PACIFIC AIR PRODUCTS CO.

Regarding: Docket #99900769/83-01

Regarding: Texas Utilities Generating Co.
Comanche Peak Steam Electric Station
Gibbs & Hill Project 2323
Spec. 2323-M5-84
PAPCo Job # 5800

ITEM II: BLADE LOCKING CLIPS (Air Balance Co.)

PHOTO 6

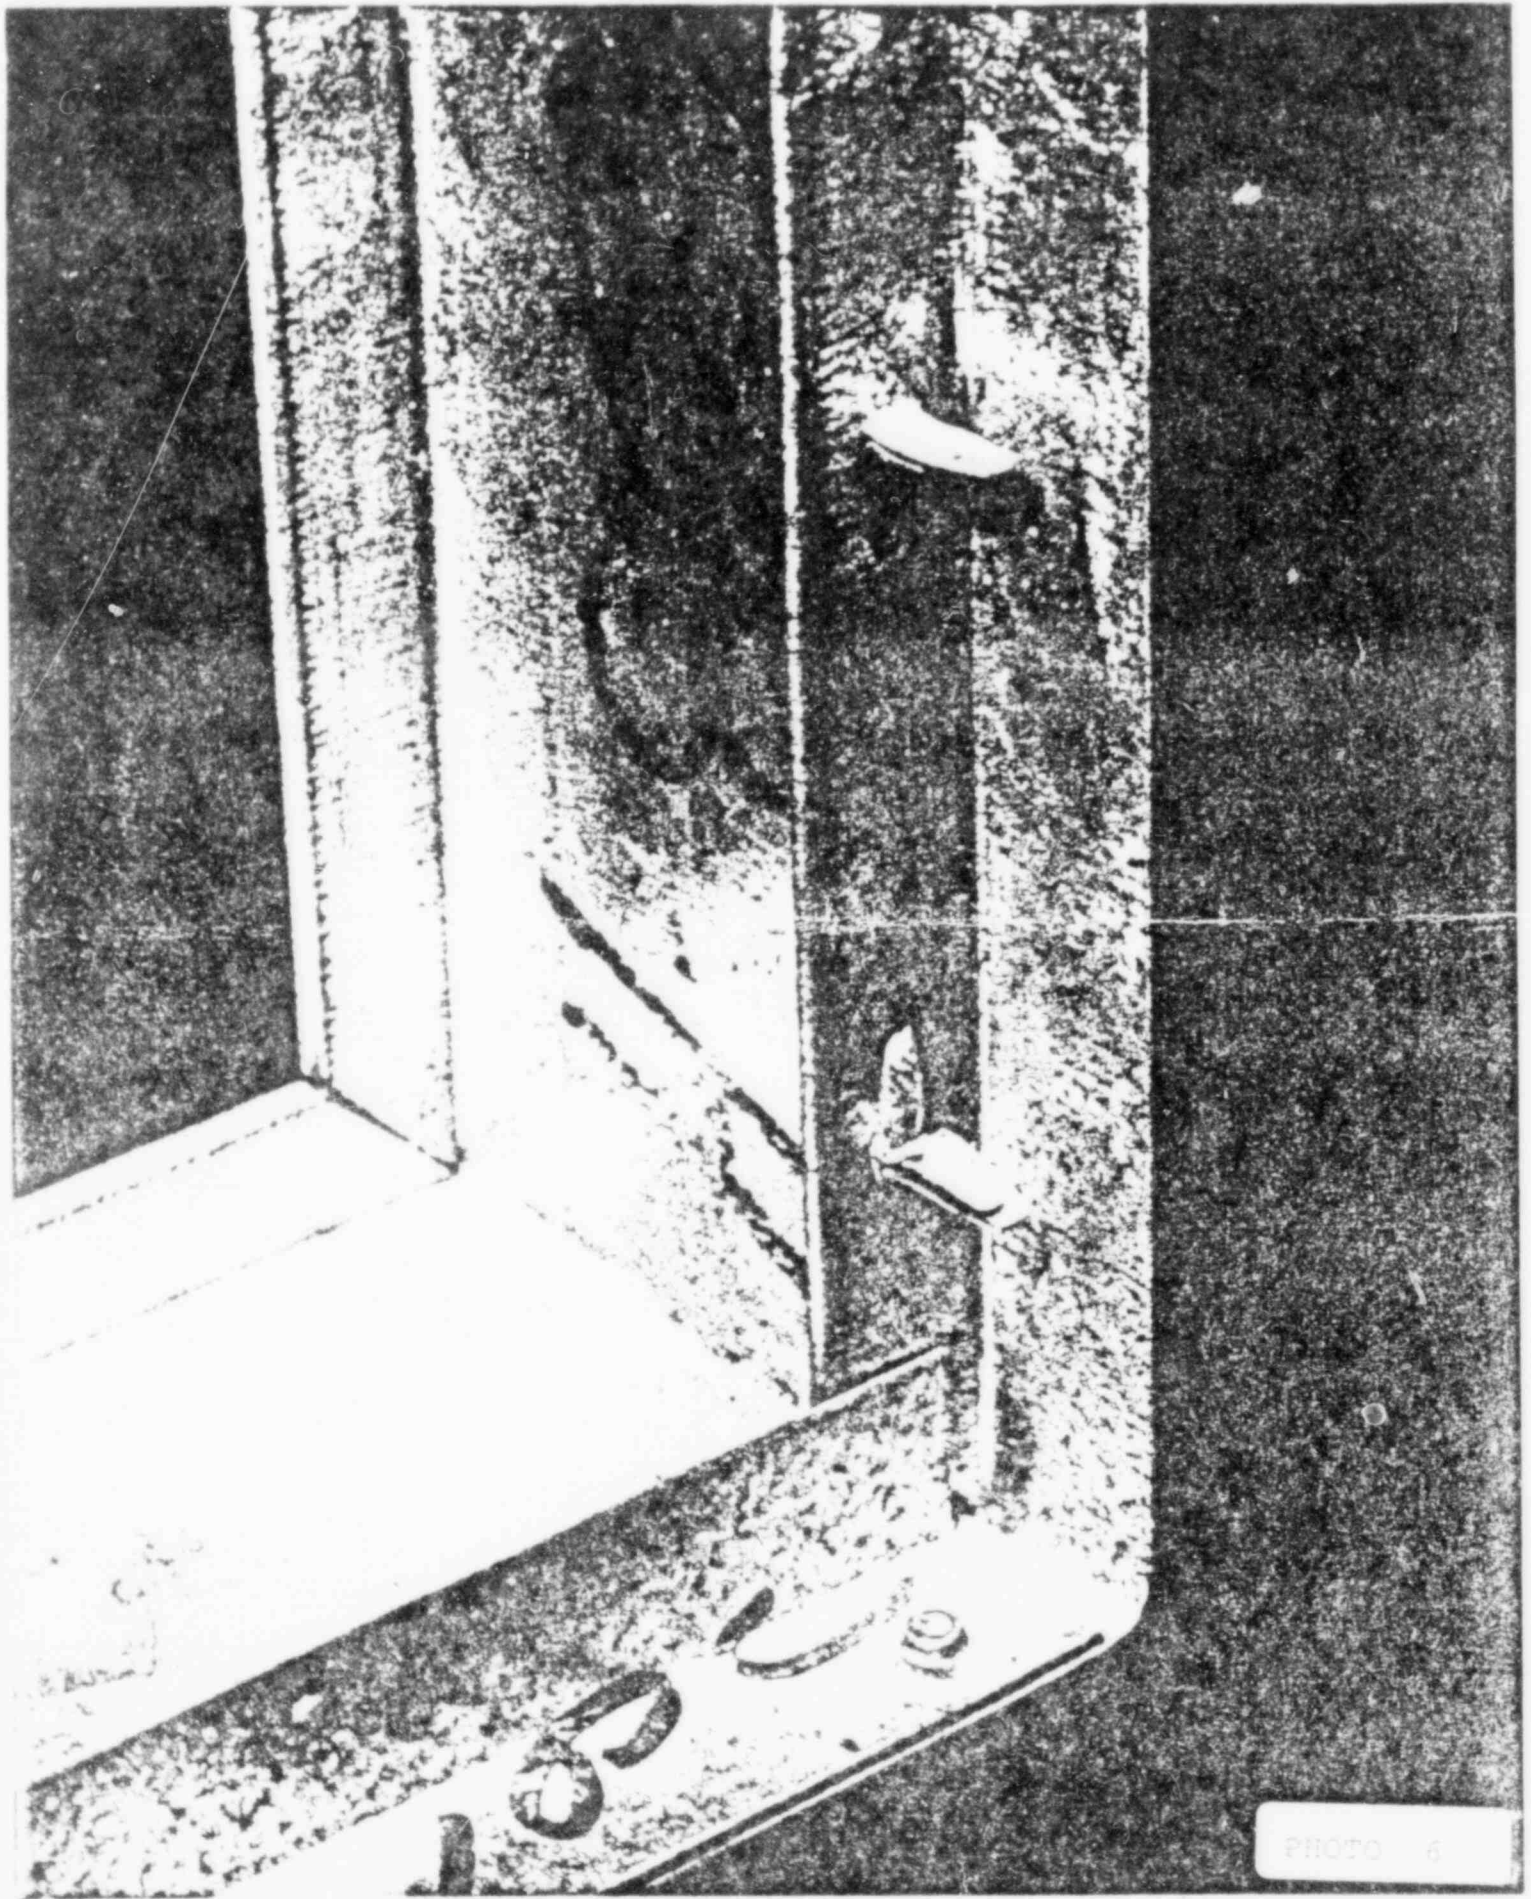
CONCERN: That some of the blade locking clips have literally fallen off due to the action of the damper.

In my opinion, the method for attaching the blade lock assembly is adequate for the intended purpose (See Photo No. 6, 7, & 8).

I believe that some of the dampers on the site were affected by "Monday morning syndrome" and the factory assembler bent the tabs that hold the blade locking clip to the damper frame backwards (or not at all).

EXAMPLE: If the two tabs are bent down toward the bottom of the damper, the blade striking the damper would not loosen the clip but the action of opening the damper would.

If the two tabs were bent up towards the top of the damper, the blade striking the blade locking clip would loosen and probably dislodge the blade locking clip. If the top clip was bent up and the bottom clip bent down, the blade clip should be secure. This is the factory recommendation and field proven method.

SOLUTION: The fire dampers on the site should be inspected to determine that all blade locking clip tabs are properly secured.

If the blade locking clips are improperly secured, then the blade locking clip should either be secured in the proper manner or the blade locking clip should be pop riveted in place per the procedure furnished by Air Balance Company.
